# PERMIT

SEWAGE DISPOSAL SYSTEM

A REPAIR

ADDRESS 13775 Triadelphia Road, Glenelg, Maryland PHONE 988-9270

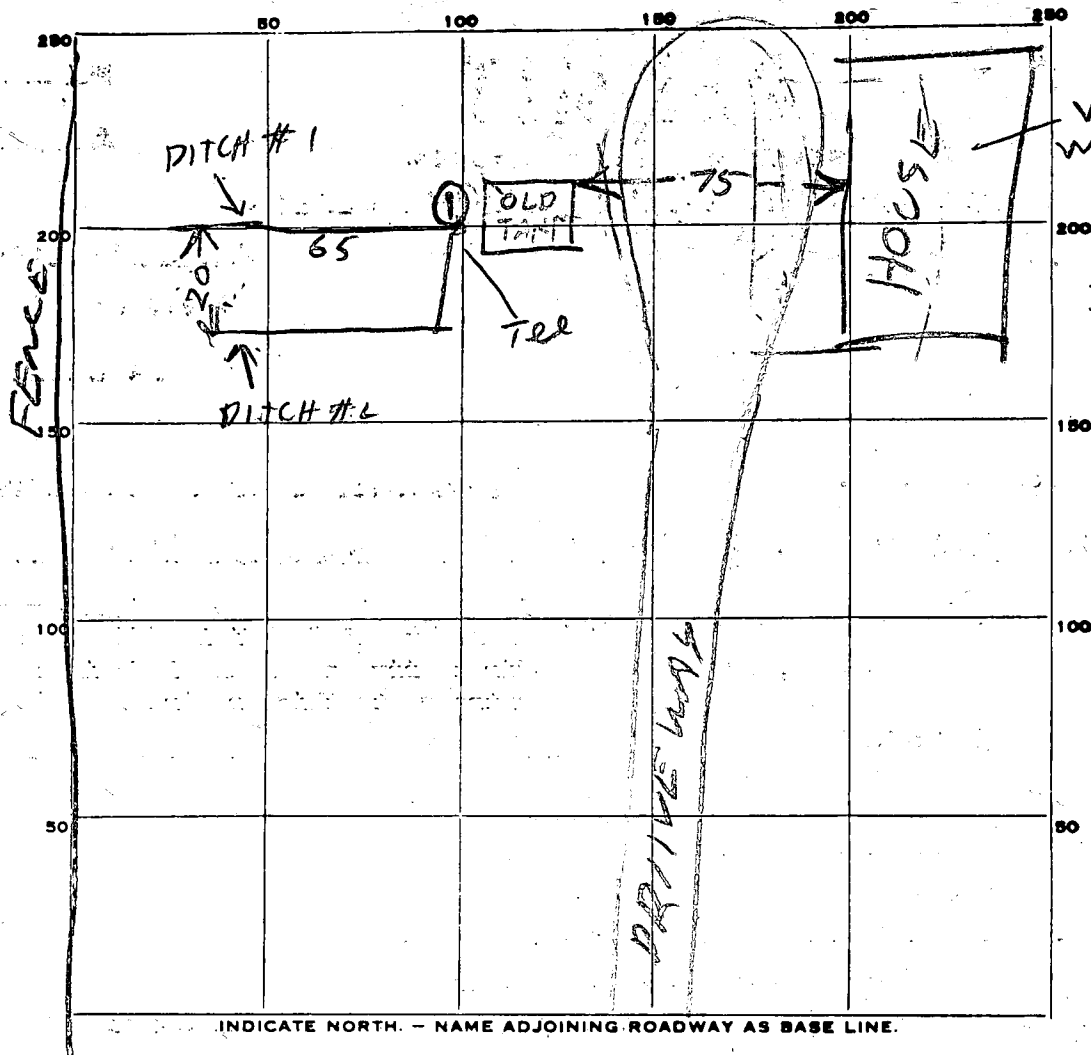
10-6-80 SK + RH REPAIR  
120' Trench Max depth 10', 5' stone below pipe, effluent area 3'-10'

REMARKS 60 OCT 90 AM PERC HOLE DUG AT ① 3FT DEEP, FAILED  
PERC TOO SLOW, SEE SOIL PROFILE. ADD STONE TO DITCH #1  
DIG DITCH #2. 20 OCT 80 PM DITCH #1 OK TO COVER  
ADD STONE TO DITCH #1. R H B SK 10-7-80 OK TO  
close all work.
